Project Name: Edendale Crossing

Description: Preliminary site plan approval recommendation and rezoning approval recommendation

RE: Edendale Crossing- Preliminary Site Plan Review – 3rd Review

**Preliminary Site Plan / Site Condominium / Planned Development Review
for
White Lake Charter Township, Michigan**

R1-D ZONING : PARALLEL PLAN

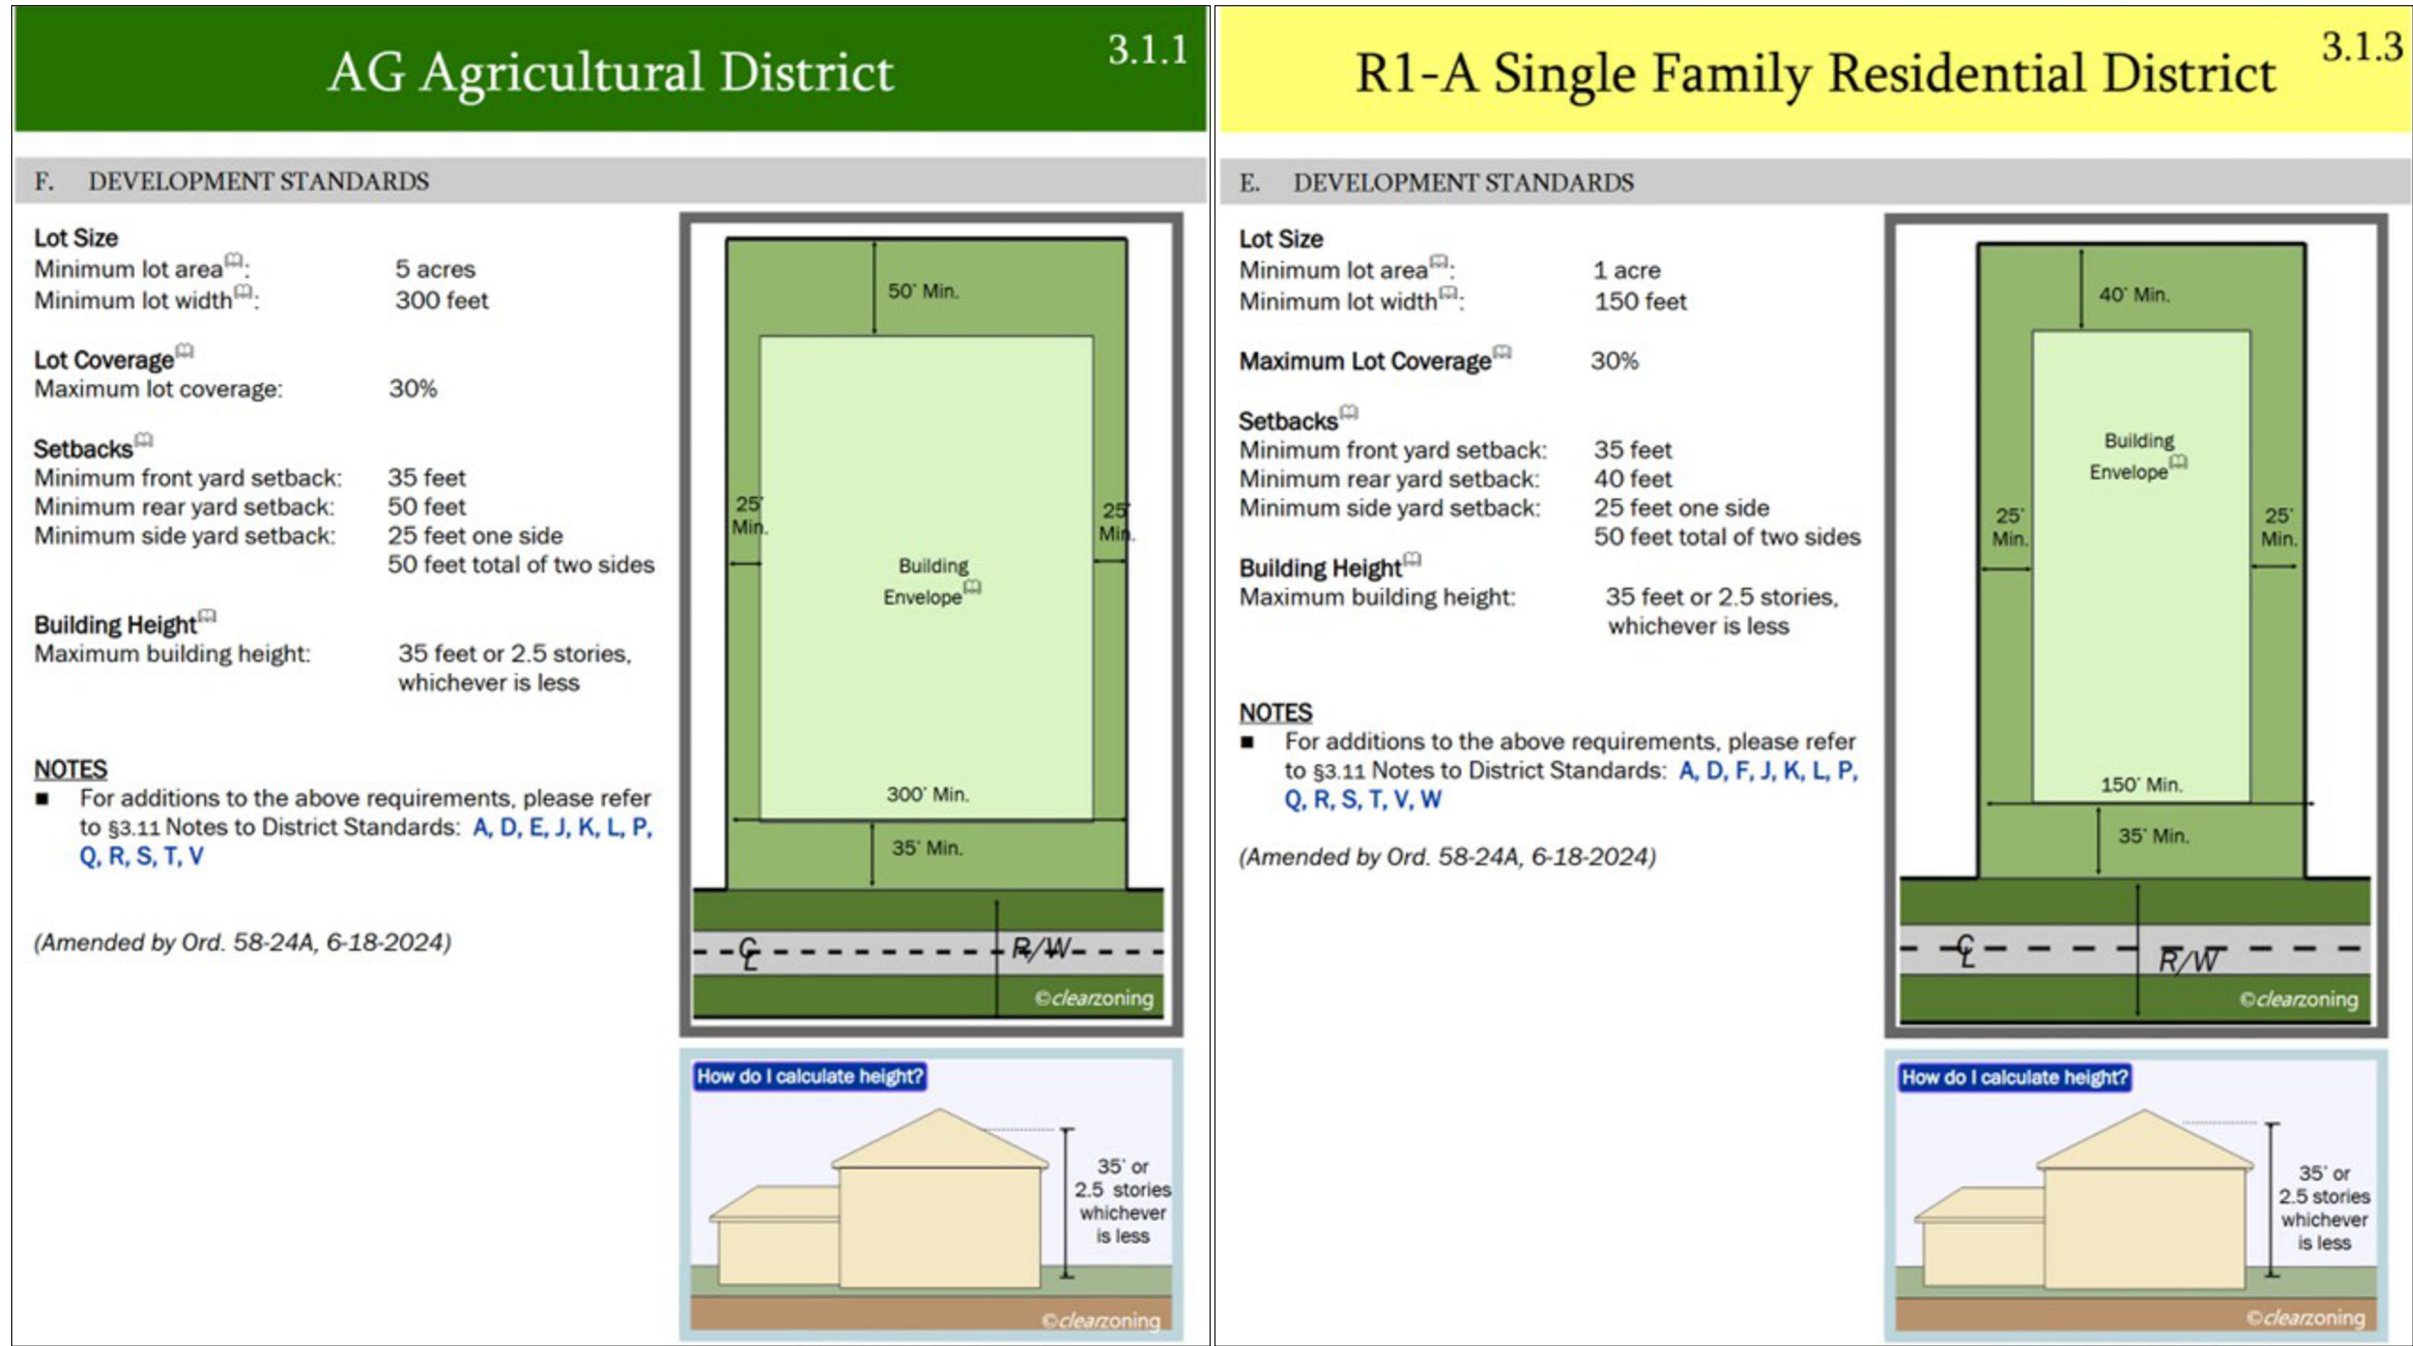
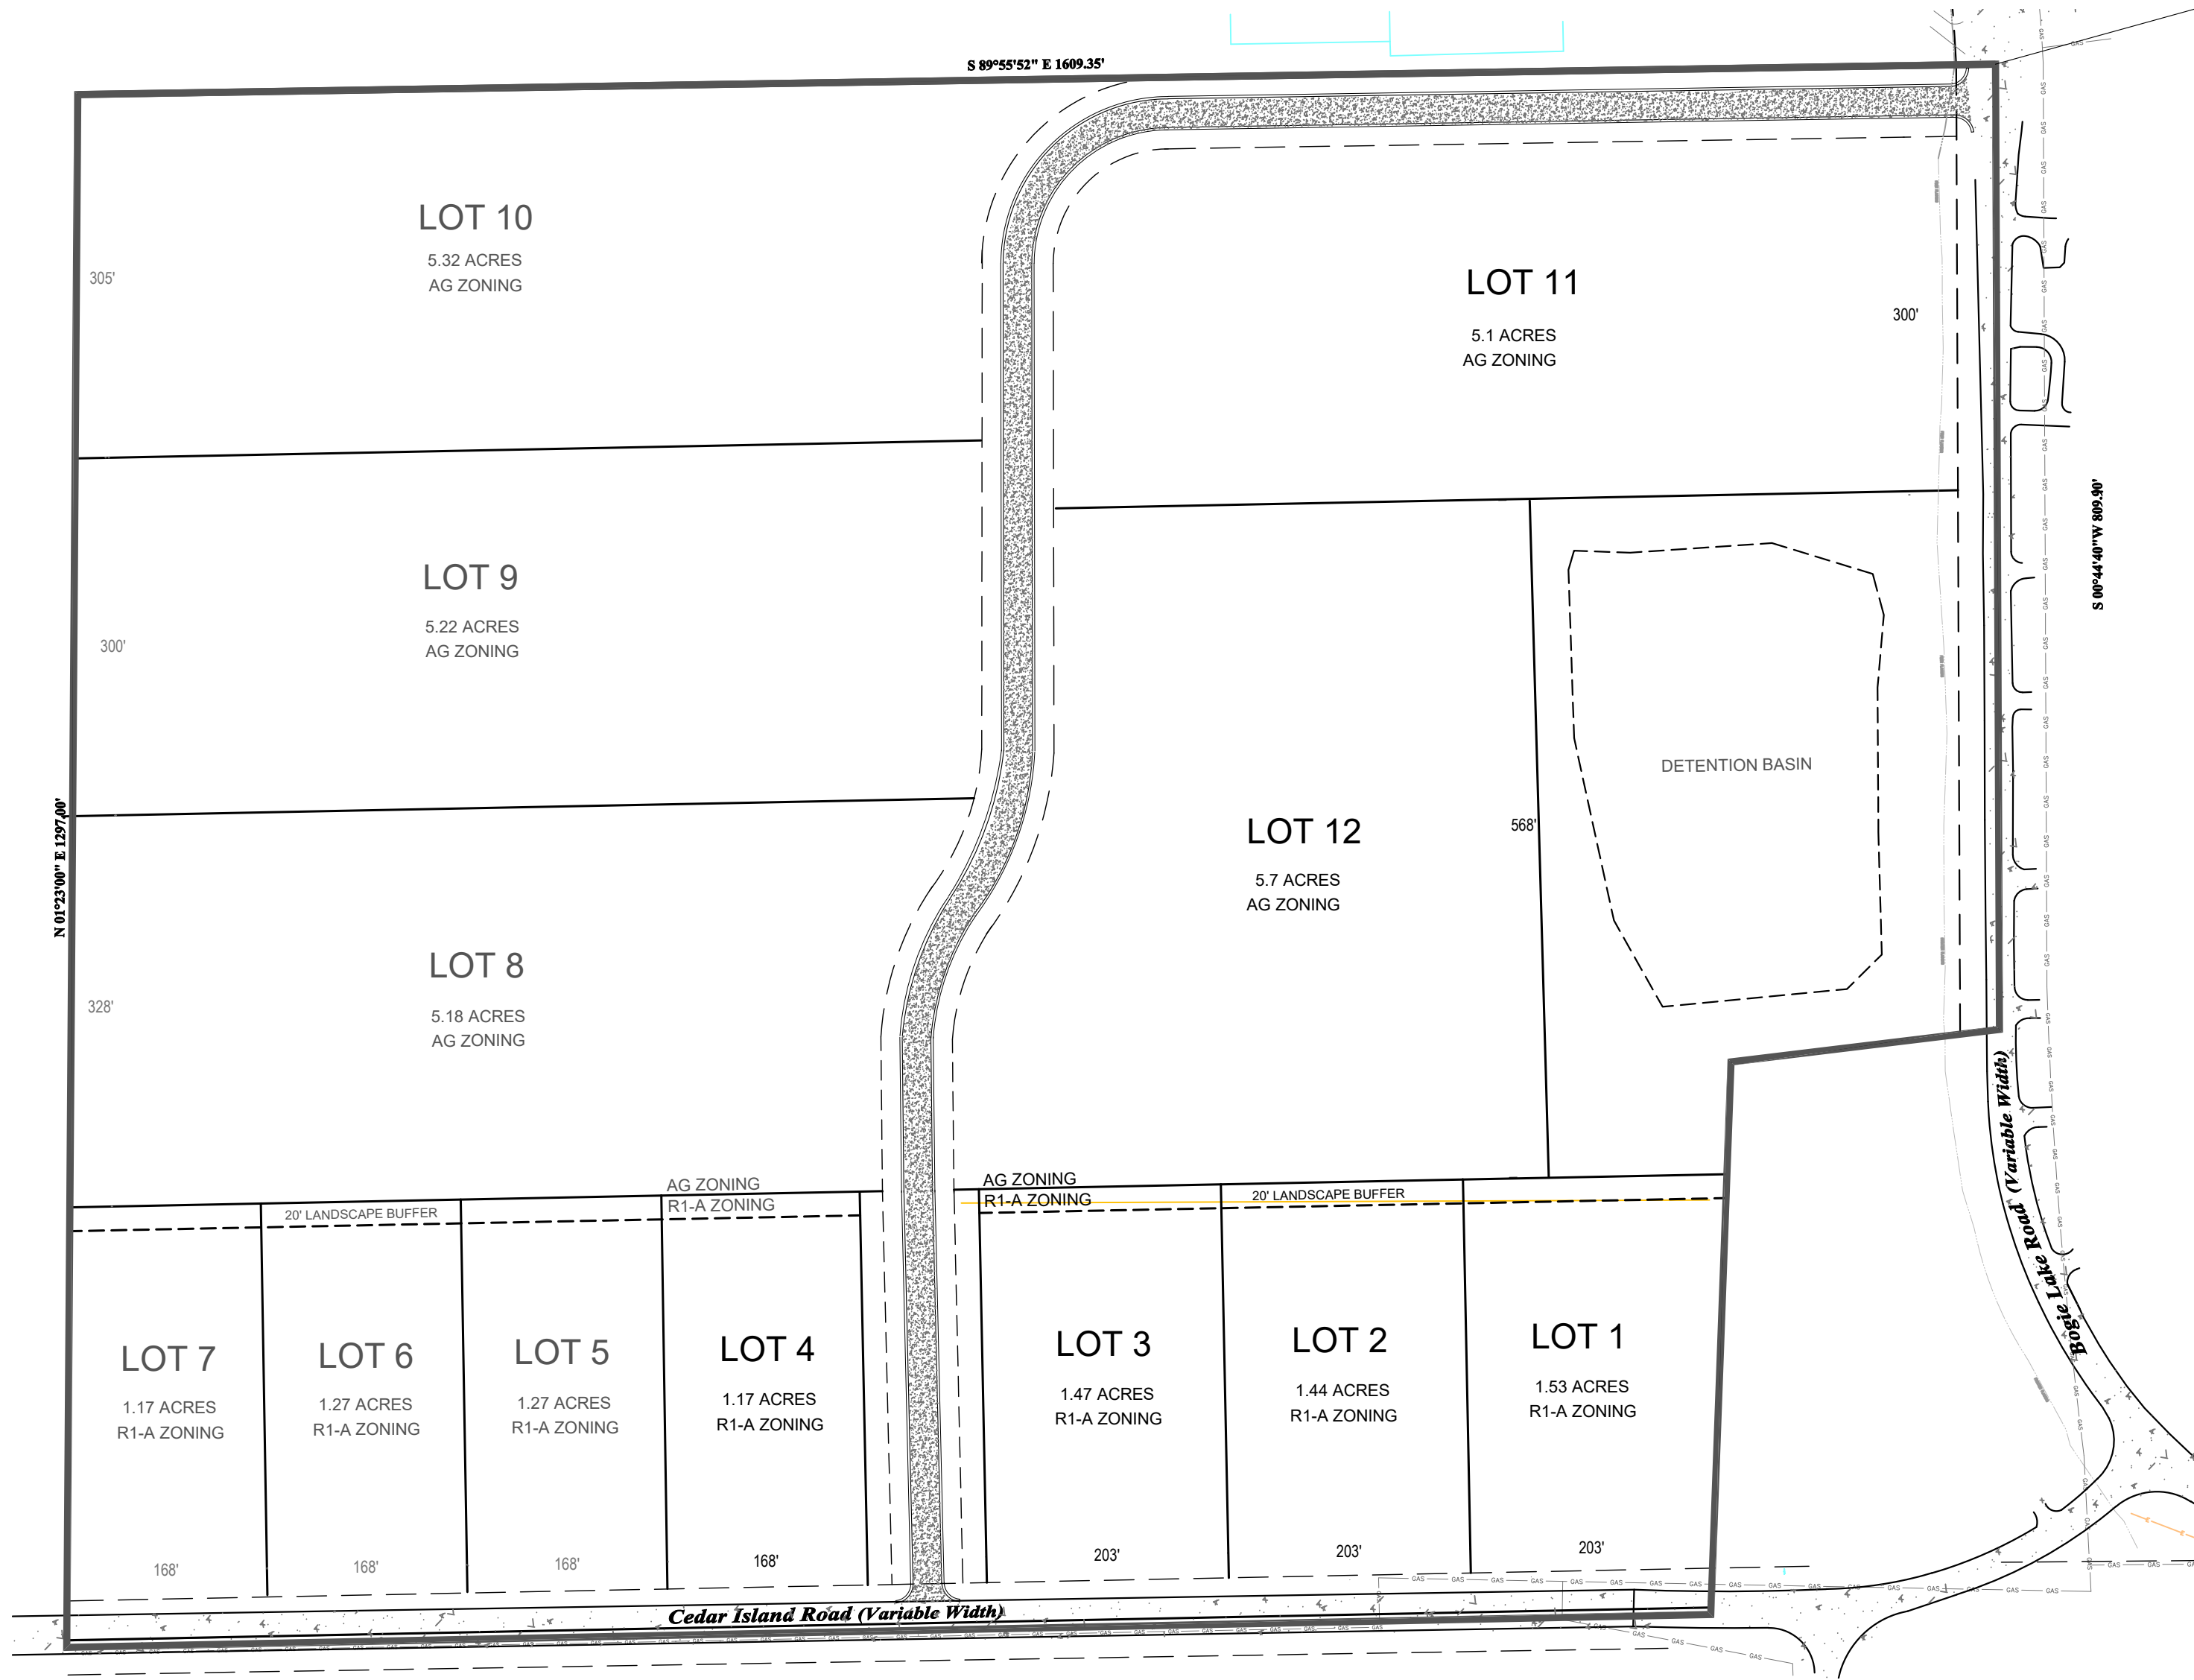
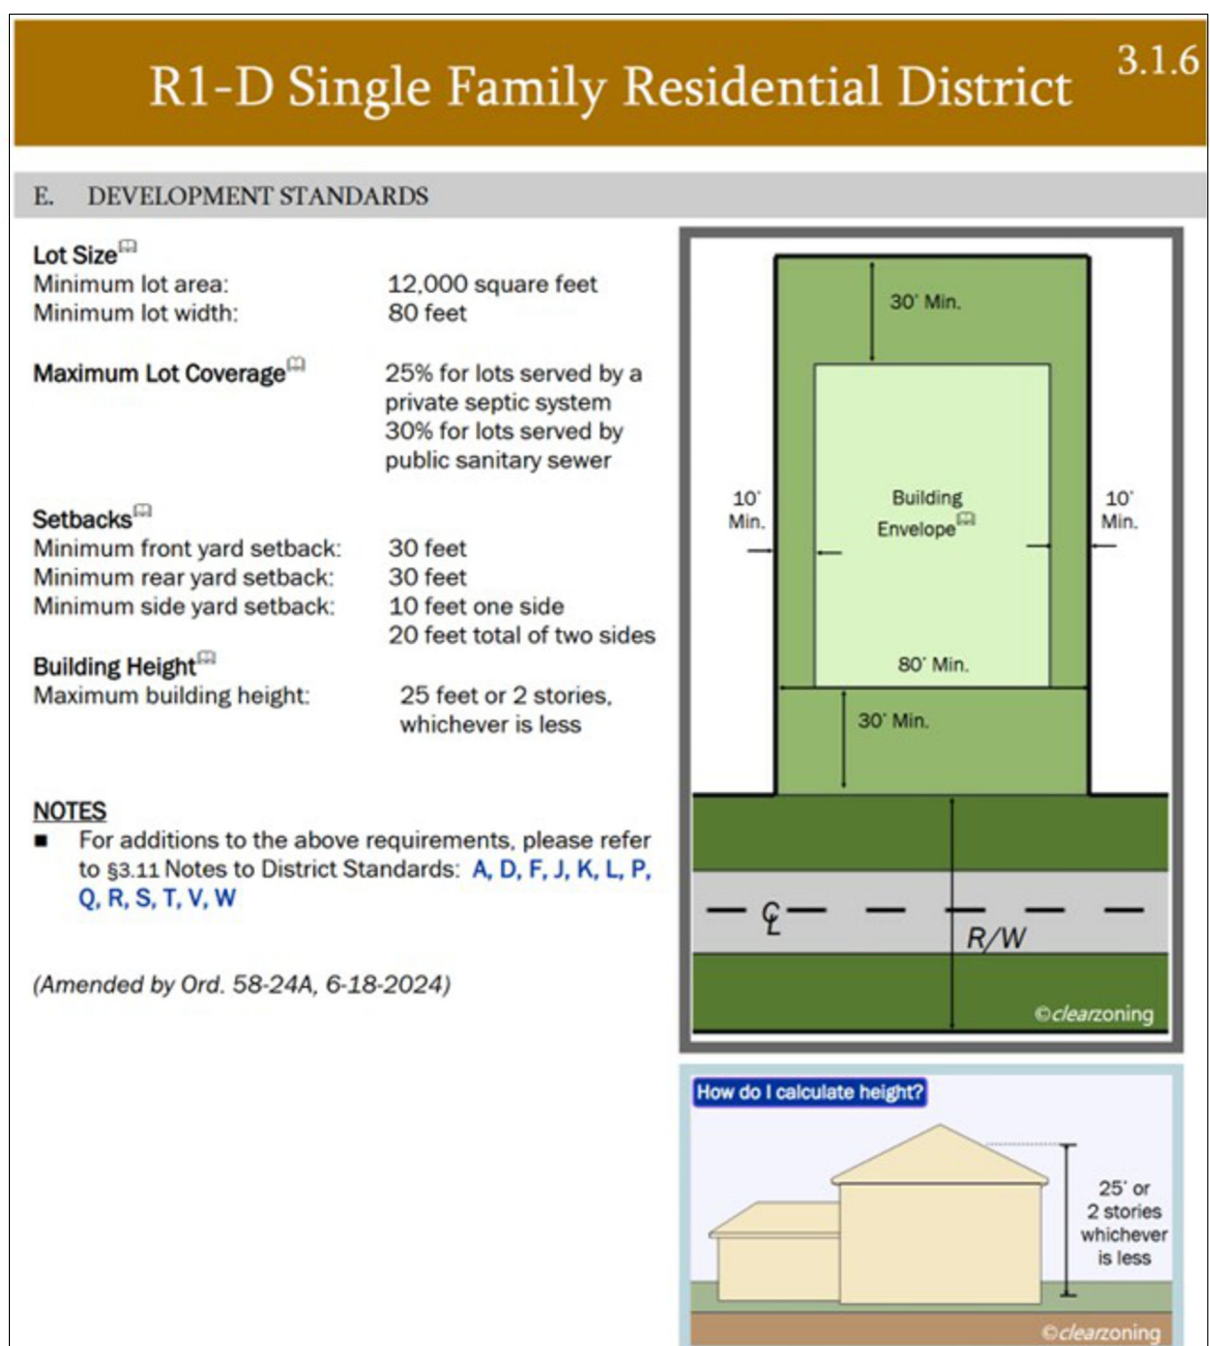
Sheet PSP-2 provides two parallel plans. One plan depicts the site developed under the current zoning (R1-A and AG). The other shows the site developed under the R1-D zoning which is the most comparable to the level of density proposed in the preliminary plan. Under current zoning, the site could be developed into 12 lots, each with a single family home. The site developed under R1-D would allow for 109 lots, each with a single family home. Per the lack of regulated wetlands, major natural features, and no requirement for open space in permitted by right R1-D and Condominium developments, the proposed development footprints of the two parallel plans are valid.

Per the Master Plan Future Land Use designation, the R1-D zoning district is the relevant zoning designation to compare deviations to. Density and dimensional deviations are provided in the Area, Width, Height, Setbacks portion of this review. For reference, proposed density is 3.47 units per net acre while providing 20.7% open space. Density under R1-D would be 3 units per net acre with no requirement for open space.
